RESPONSE TO ASSESSMENT REPORT AND PUBLIC SUBMISSIONS THE STAR MODIFICATION 13 TO MP08_0098

6 SEPTEMBER 2019
FINAL
PREPARED FOR THE STAR ENTERTAINMENT GROUP LIMITED

Figure 3 – Original and Revised Building Height

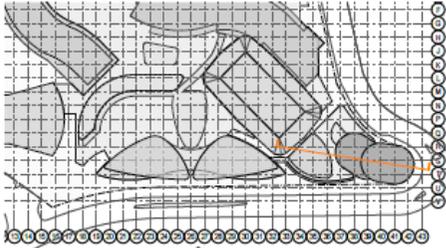
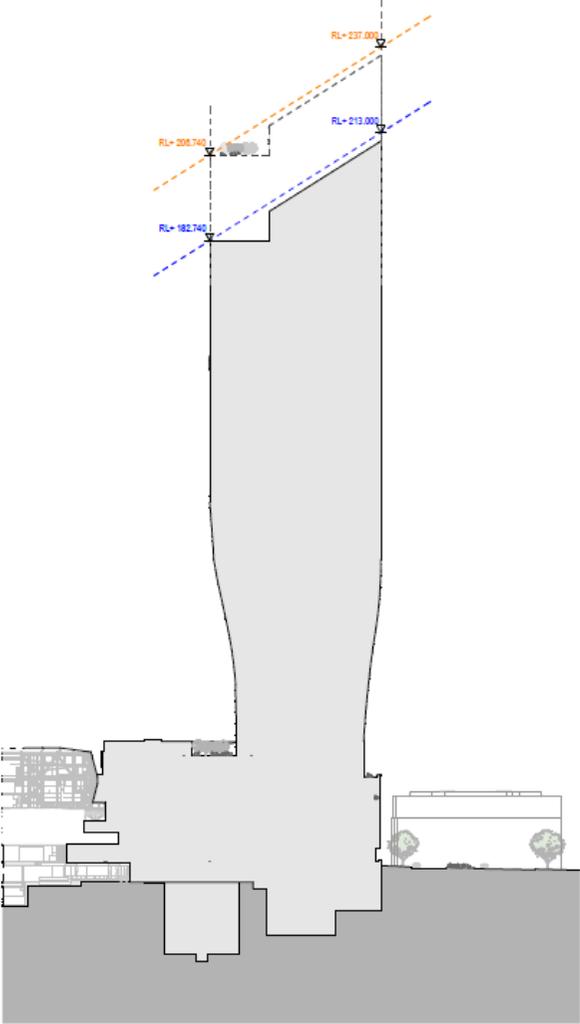
FJMT, the Proponent's Architect, detailed in the presentation to the IPC, the maximum height of the tower presented as part of the Design Excellence Process had a maximum height of RL 213 and a maximum building height of 210.3m (refer blue line in **Figure 3** below). This height was nominated to prevent overshadowing of Union Square..

FJMT presented an alternative height for the consideration of the DRP as part of the second phase of the Design Excellence process. The revised scheme (which forms the exhibited Proposal) has a maximum RL of 237 and a maximum building height of 234.3m (refer orange line in **Figure 3** below). The DRP supported the taller scheme as they considered it to *'achieve more elegant proportions with negligible additional environmental impacts'* (Design Review Panel, December 2016).

Figure 4 – Neighbourhood Centre

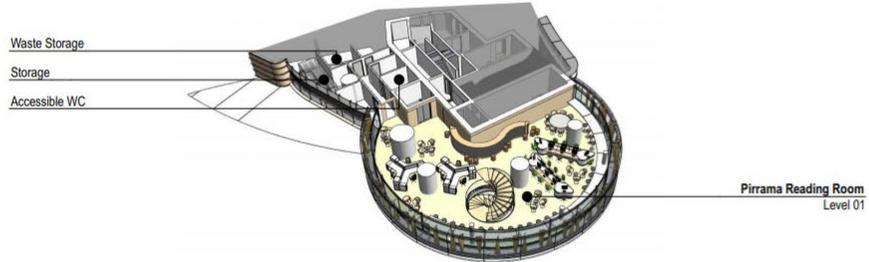
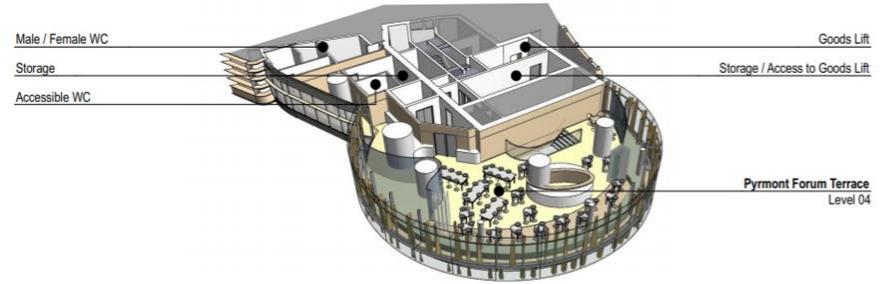
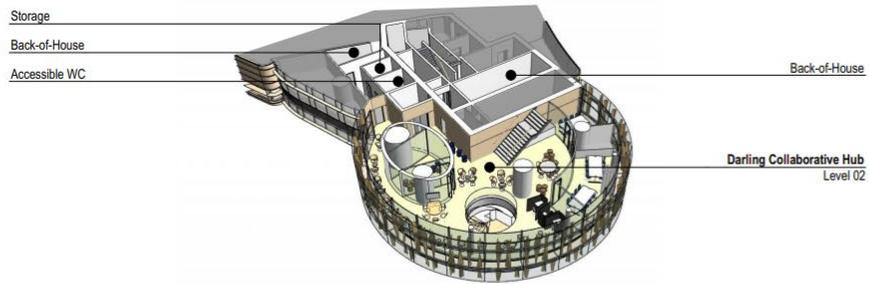
The IDA (page 138), states; *'The application does include 'Neighbourhood Centre' facilities within the development at ground floor level'*. The Proponent confirms the extent of the Neighbourhood Centre as being across five levels, (ground floor and levels 1, 2, 3 and 4) and having a floor area of 1,690sqm as detailed in **Figure 4**. A breakdown of each level is as follows:

- Level 00 Ground Level – community lounge and terrace, outdoor terrace, Enterprise Café, Technology Bar, makers space;
- Level 1 – Reading room and library space, elevated lounge, children and family space, space for study and group setting;
- Level 2 – Open plan training and class settings, casual group lounge settings, consultation and tutoring settings, meeting rooms and conference spaces, community and digital literacy classes;
- Level 3 – Civic function space with harbour views, dual purpose catering and neighbourhood kitchen, access to Harbour Roof Terrace, private and community functions; and
- Level 4 – Community terrace with harbour views, green space and seated settings, private and community functions.

Figure 26 – VIA Extract

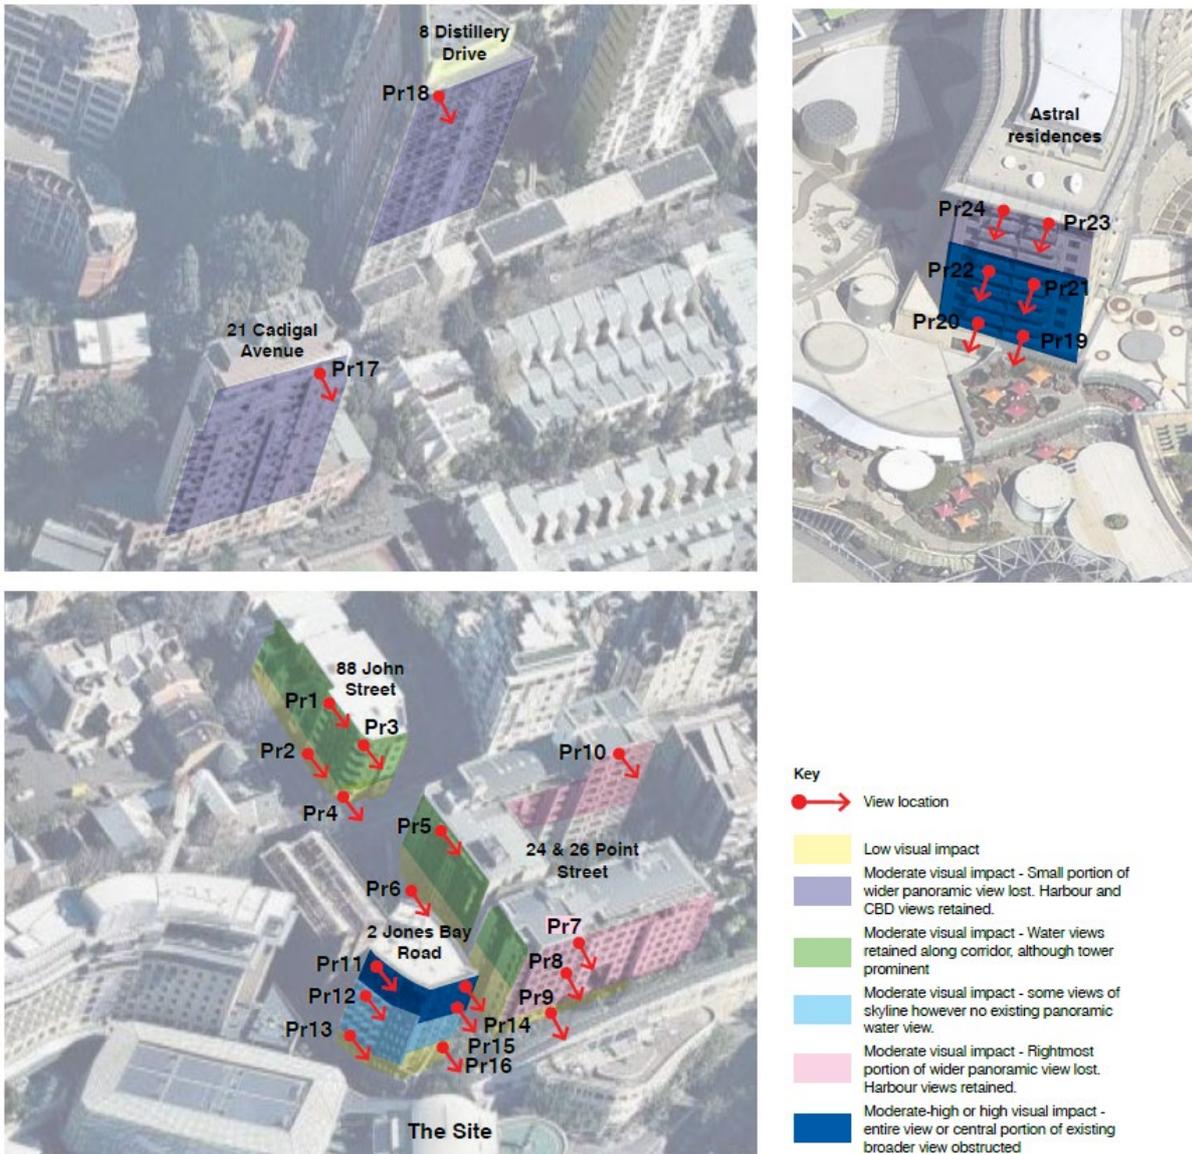
Both the Department's AR and the VIA are broadly consistent in terms of assessment of individual views, however there are some differences in the categorisation of impact. The impact is summarised on the diagram below (**Figure 26**) from the VIA (EAR, Appendix H), with the Department's assessment having a slightly higher categorisation of three views Private residence 21, Private residence 22 and Private residence 12.

- high and moderate to high impacts:*
 - approximately 16 apartments in 2 Jones Bay Road, of which approximately 13 also received a 'high' impact from the previous MOD7 approval (this Proposal will remove the majority of the view which remained after MOD7).*
 - approximately 14 apartments within the Astral Residences.*
- moderate impacts (generally a significant portion of view is retained) - further apartments in Jones Bay Road, 88 John Street, 24 & 26 Point Street, 8 Distillery Drive, 21 Cadigal Avenue and upper levels of the Astral Residences."*

Figure 27 – Building Height (RL 213)

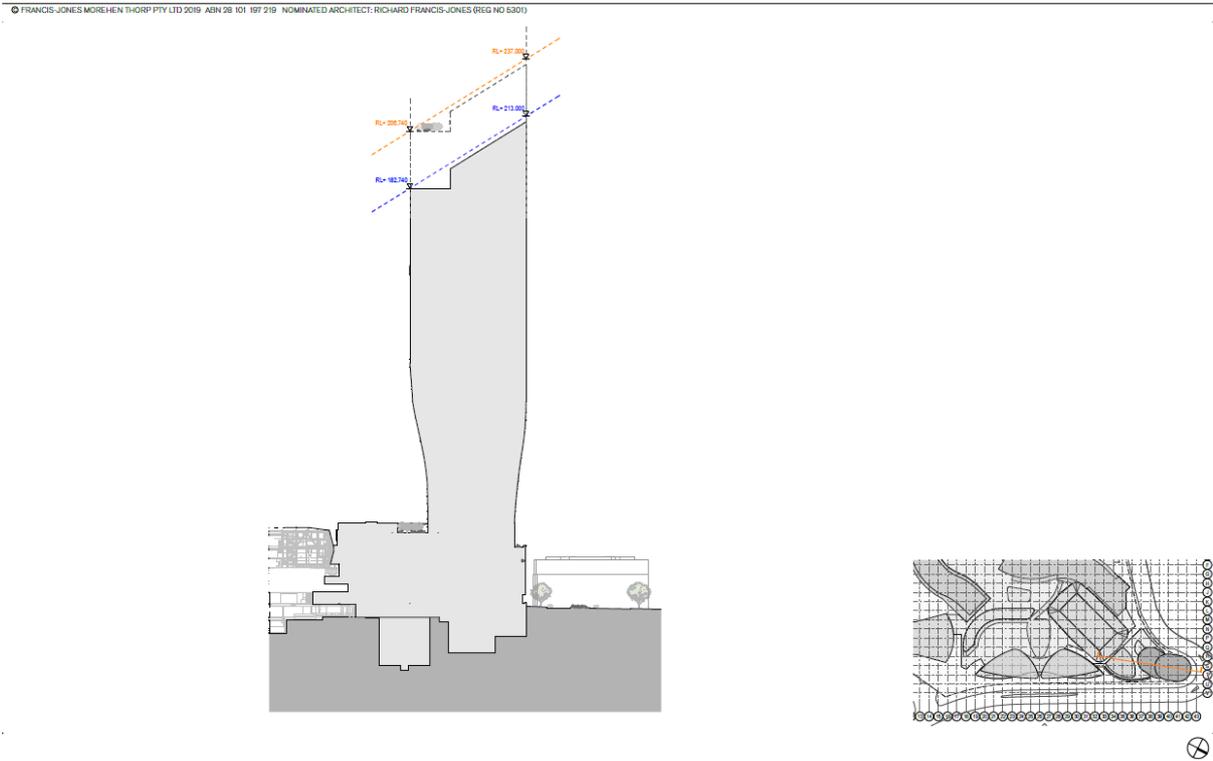
If the IPC considers that the overshadowing of Union Square and the intrusion of the tower into the view corridor of the GPO when viewed from within Martin Place are not appropriate, this impact can be addressed by the lowering of the tower height to RL 213 as detailed in **Figure 3** prepared by FJMT. The reduction in the tower height to RL 213 will remove overshadowing to Union Square. In addition, this reduced height Proposal would further reduce the minor shadow impacts to Pyrmont Bay Park, western approach to Pyrmont Bridge and the Clifftop Walk and will reduce the intrusion of the tower when viewed from Martin Place (refer **Figure 30**).

A tower form with a maximum height of RL 213 (original competition scheme) would remove overshadowing from Union Square. In addition, this would reduce the minor shadow impacts to Pyrmont Bay Park, Pyrmont Bridge and the Clifftop Walk. FJMT has undertaken additional modelling of this scenario and extracts are provided at **Figures 27, 28 and 29**.

If the IPC considers that the overshadowing of Union Square and the intrusion of the tower into the view plane of the GPO when viewed from within Martin Place is not appropriate, this impact can be mitigated by the lowering of the tower height to RL 213 as detailed in **Figure 27** prepared by FJMT. As shown in the shadow diagrams at **Figure 28, 29** and **30**, the reduction in the tower height to RL 213 will remove overshadowing to Union Square. In addition, this reduced height proposal would further reduce the minor shadow impacts to Pymont Bay Park, Pymont Bridge and the Clifftop Walk and will reduce the intrusion of the tower when viewed from Martin Place (refer **Figure 31**).
